**Loreto Kirribilli
Innovation Centre**
SSD Modification (s4.55)

Project Name		Loreto Kirribilli - Concept Master Plan and Stage 1	
Project Code		LKIC	
Document Name		SSD Modification Report (s4.55)	
Document ID		190715 Modification Report	
Revision	Date	Comment	Approved
00	04.06.2019	Draft for Information	EC
01	17.06.2019	Draft for Information	EC
02	27.06.2019	Final Draft	EC
03	12.07.2019	Response to Request for Additional Information	EC

1.0 Response to Request for Additional Information

Modified s4.55 Elamang Avenue Elevation

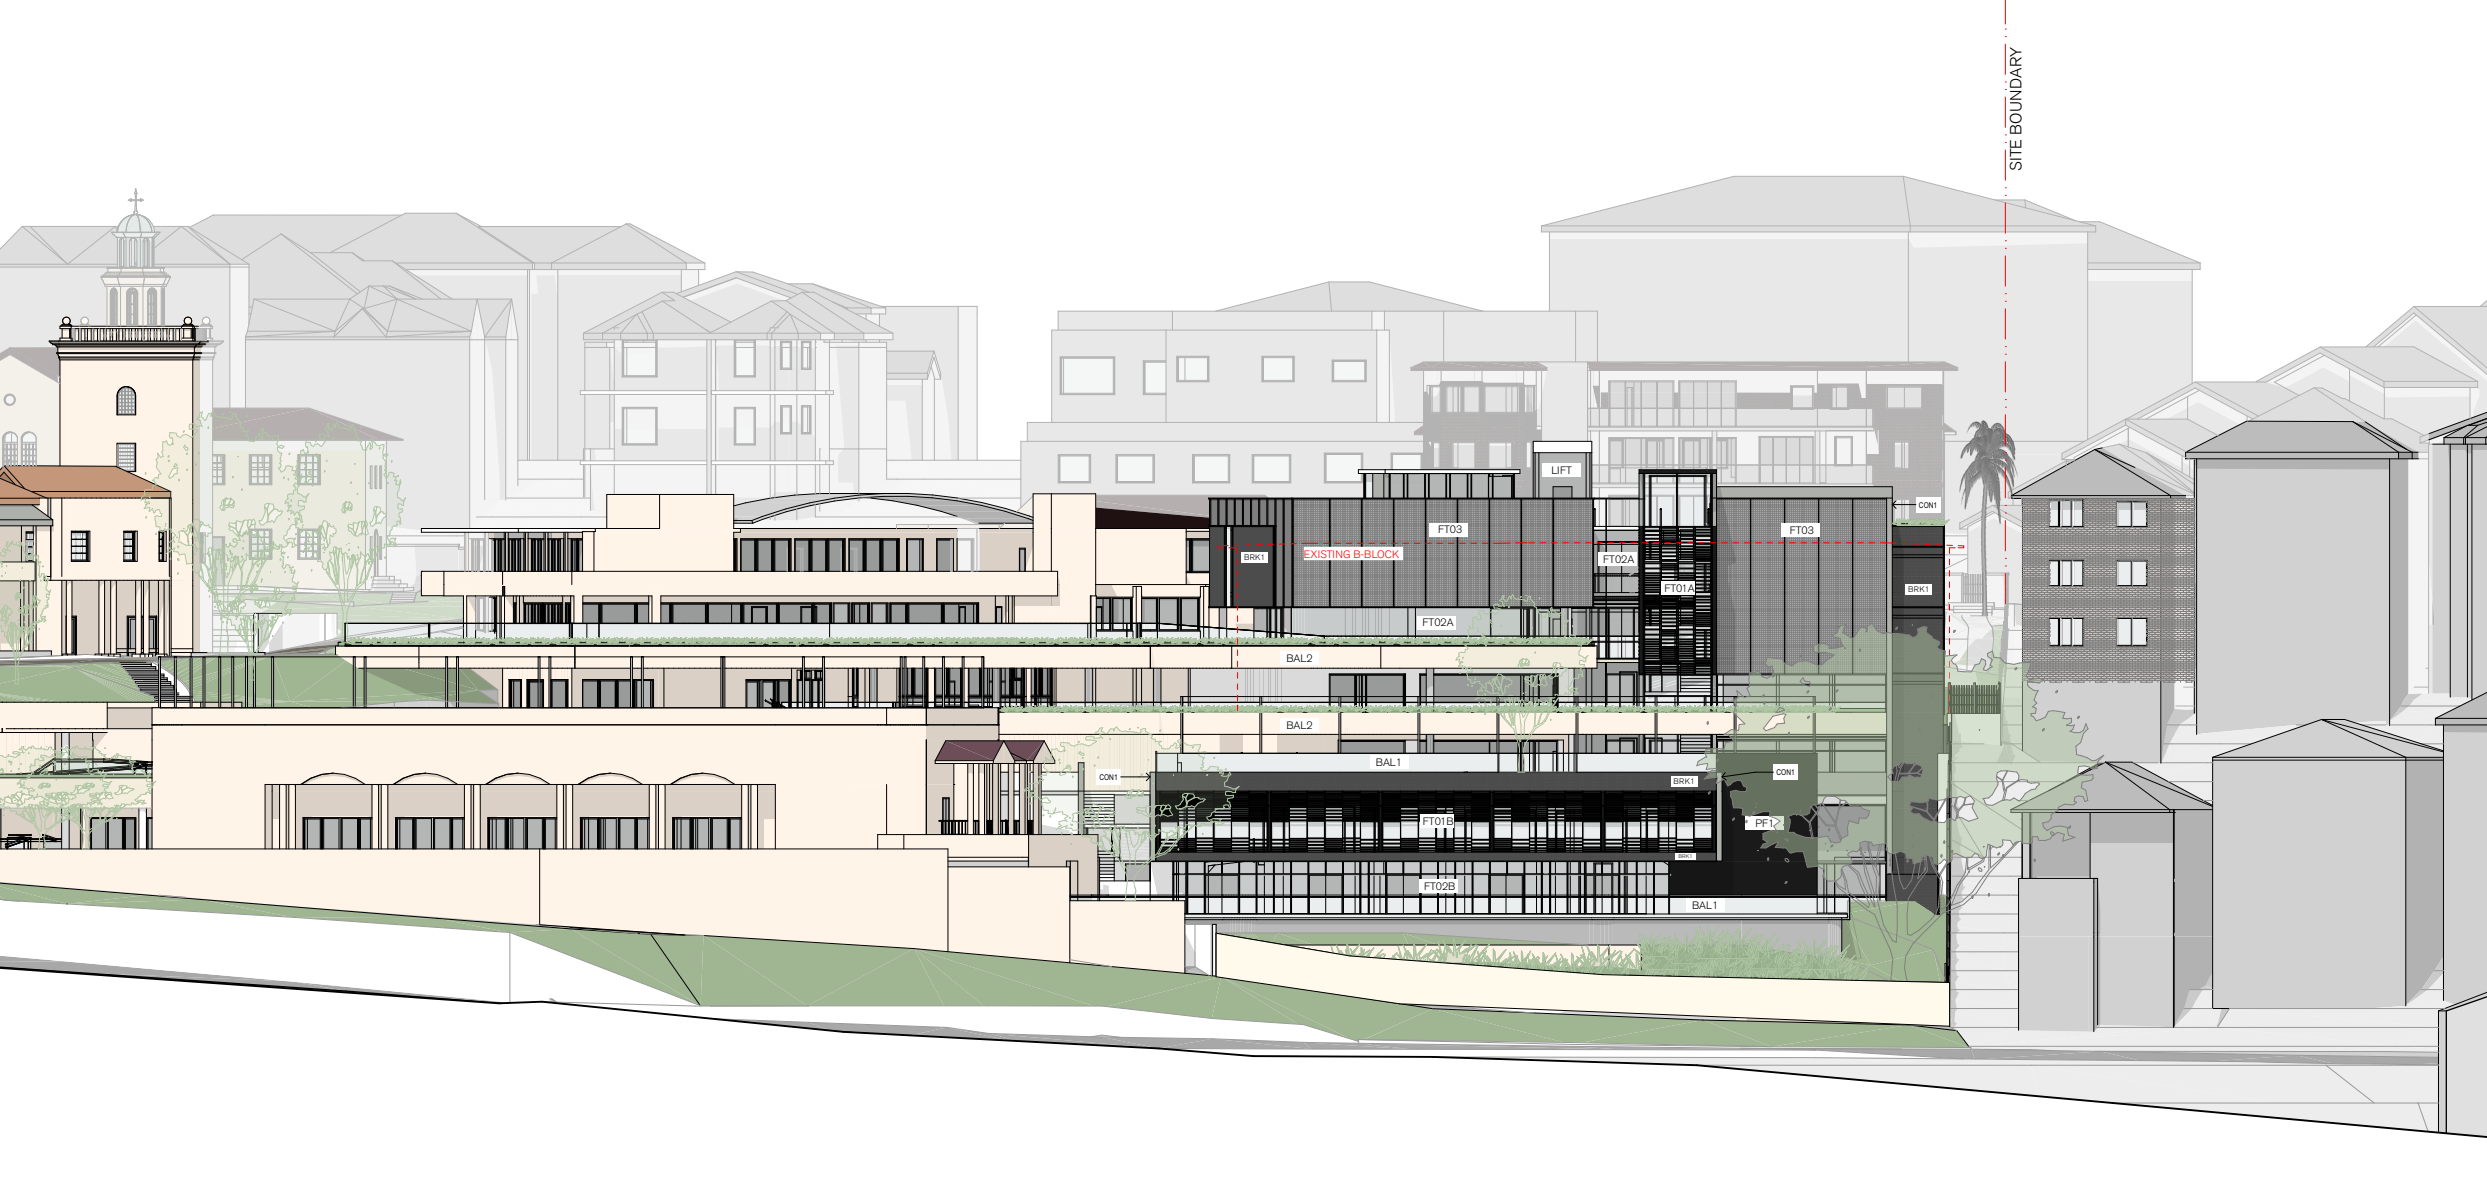
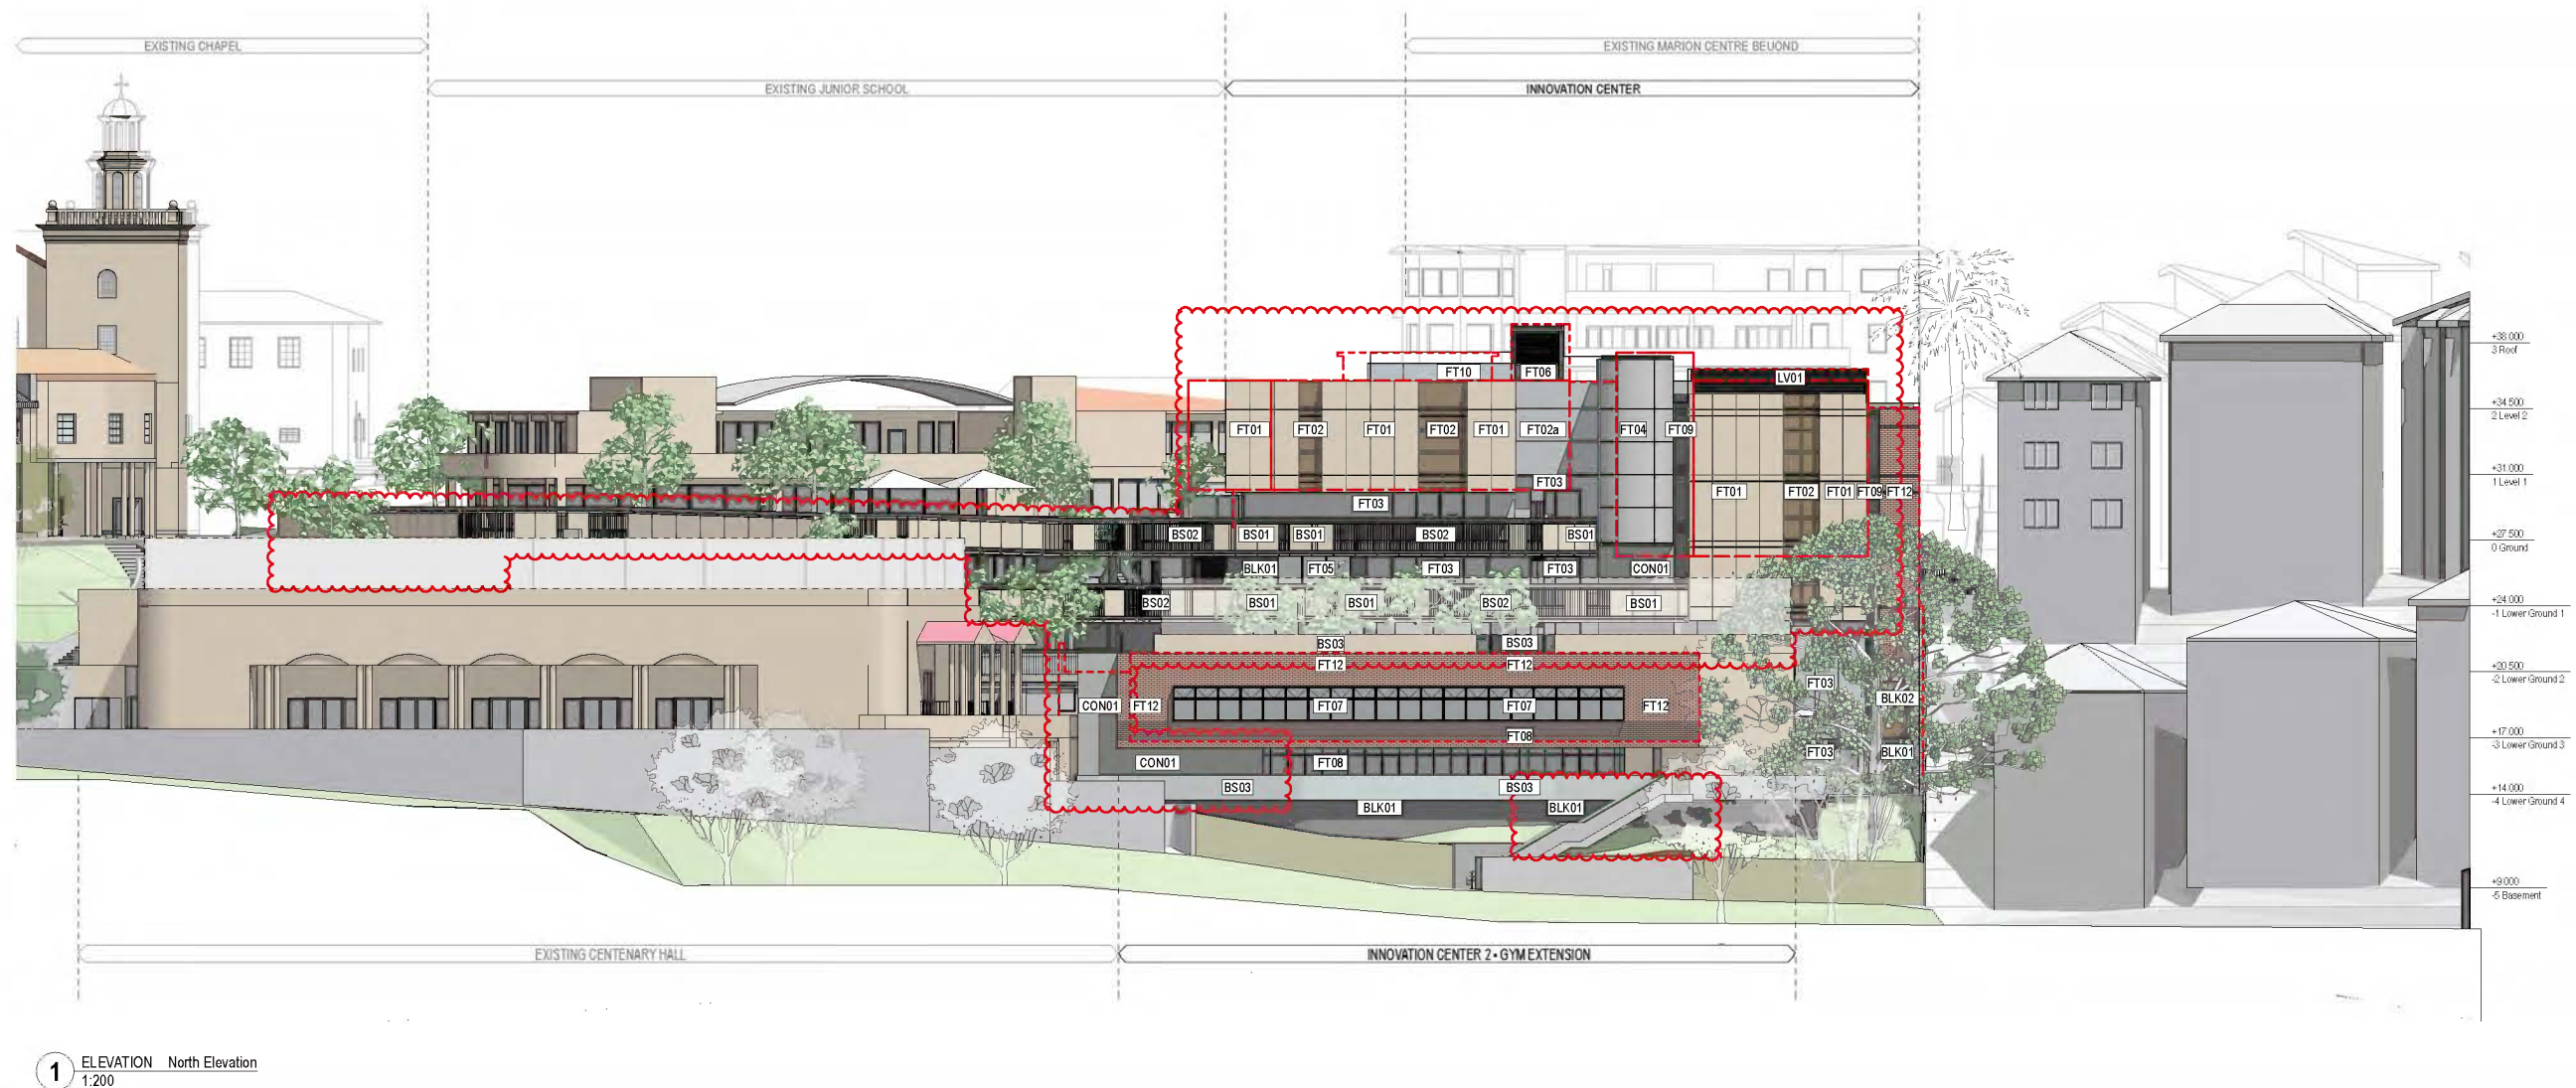
Location		Facade Code	Approved SSD	Facade Code	Modification
1	“Connector” Stair				
1.1	East, north and west elevations of northern stair	FT01A/B	Aluminium battens with glazing The facade to the northern stair will be protected by dark bronze toned powder coat or anodized aluminium louvres which will provide the appropriate solar performance.	FT04	Frameless performance curved glazing
2 Gymnasium Extension
